**TSG-RAN Meeting #15**  
**Jeju-do, Korea, 5 - 8 March 2002**

**RP-020069**

**Title:** Agreed CRs (Release '99 and Rel-4 category A) to TS 25.323

<b>Title:</b>	⌘ Clarification on PDCP sequence numbering		
<b>Source:</b>	⌘ TSG-RAN WG2		
<b>Work item code:</b>	⌘ TEI	<b>Date:</b>	⌘ 2002-2-18
<b>Category:</b>	⌘ <b>F</b>	<b>Release:</b>	⌘ R99
	<i>Use <u>one</u> of the following categories:</i> <b>F</b> (correction) <b>A</b> (corresponds to a correction in an earlier release) <b>B</b> (addition of feature), <b>C</b> (functional modification of feature) <b>D</b> (editorial modification) Detailed explanations of the above categories can be found in 3GPP <a href="#">TR 21.900</a> .		<i>Use <u>one</u> of the following releases:</i> <b>2</b> (GSM Phase 2) <b>R96</b> (Release 1996) <b>R97</b> (Release 1997) <b>R98</b> (Release 1998) <b>R99</b> (Release 1999) <b>REL-4</b> (Release 4) <b>REL-5</b> (Release 5)

**Figure 2: PDCP data transfer over acknowledged mode RLC**

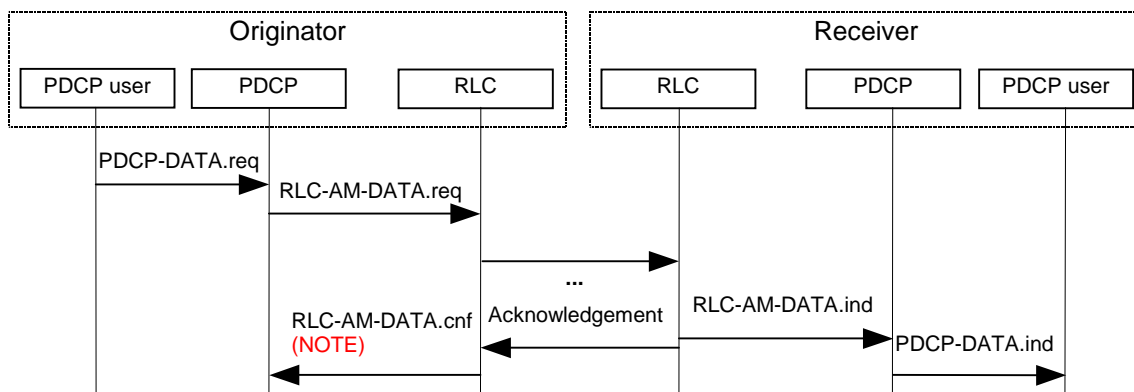
<b>Reason for change:</b>	⌘ <ol style="list-style-type: none"> <li>1. Figure 2 in Section 5.3.1 is misleading. The primitive RLC-AM-DATA.cnf is delivered only if the primitive RLC-AM-DATA.req is used with parameter CNF.</li> <li>2. The PDCP sequence numbering in Section 5.4.1.1 is inconsistent with Sections 5.4.1.2 and 7.1.</li> </ol>
<b>Summary of change:</b>	⌘ <ol style="list-style-type: none"> <li>1. A note is added in Figure 2 to clarify that the primitive RLC-AM-DATA.cnf is delivered only if the primitive RLC-AM-DATA.req is used with parameter CNF.</li> <li>2. Sections 5.4.1.1, 5.4.1.2, 5.4.1.3 and 7.1 are clarified to make Receive/Send PDCP SN to mean the "sequence number" of the corresponding received/sent PDCP SDU.</li> <li>3. Some minor editorial corrections are also made.</li> </ol> <p><b>The CR has isolated impact:</b> The clarified functionality does not affect other functionalities. The CR does not change the meaning of the functionality. It would not affect implementations behaving like indicated in the CR, would affect implementations supporting the corrected functionality otherwise.</p>

**NOTE:** [If the primitive RLC-AM-DATA.req is used with parameter CNF, the primitive RLC-AM-DATA.cnf is delivered. Otherwise, this primitive is not delivered.](#)

**Figure 2: PDCP data transfer over acknowledged mode RLC**

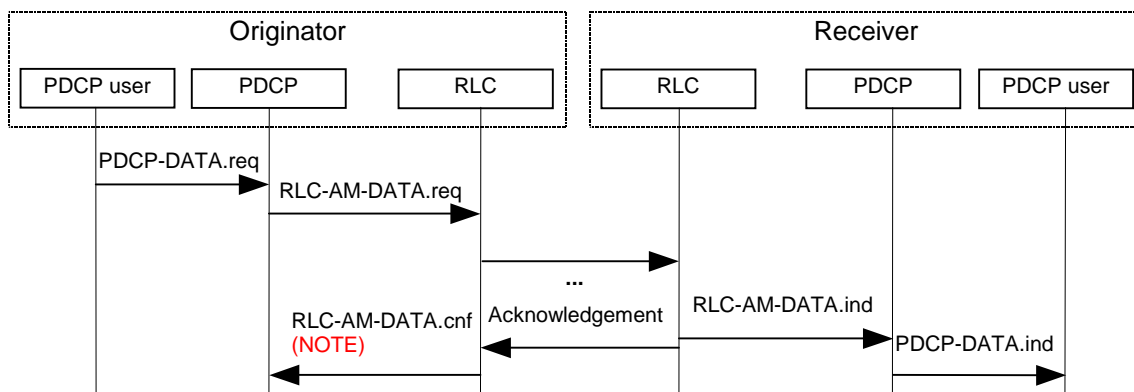
<b>Reason for change:</b>	⌘ <ol style="list-style-type: none"> <li>1. Figure 2 in Section 5.3.1 is misleading. The primitive RLC-AM-DATA.cnf is delivered only if the primitive RLC-AM-DATA.req is used with parameter CNF.</li> <li>2. The PDCP sequence numbering in Section 5.4.1.1 is inconsistent with Sections 5.4.1.2 and 7.1.</li> </ol>
<b>Summary of change:</b>	⌘ <ol style="list-style-type: none"> <li>1. A note is added in Figure 2 to clarify that the primitive RLC-AM-DATA.cnf is delivered only if the primitive RLC-AM-DATA.req is used with parameter CNF.</li> <li>2. Sections 5.4.1.1, 5.4.1.2, 5.4.1.3 and 7.1 are clarified to make Receive/Send PDCP SN to mean the "sequence number" of the corresponding received/sent PDCP SDU.</li> <li>3. Some minor editorial corrections are also made.</li> </ol> <p><b>The CR has isolated impact:</b> The clarified functionality does not affect other functionalities. The CR does not change the meaning of the functionality. It would not affect implementations behaving like indicated in the CR, would affect implementations supporting the corrected functionality otherwise.</p>

**NOTE:** [If the primitive RLC-AM-DATA.req is used with parameter CNF, the primitive RLC-AM-DATA.cnf is delivered. Otherwise, this primitive is not delivered.](#)
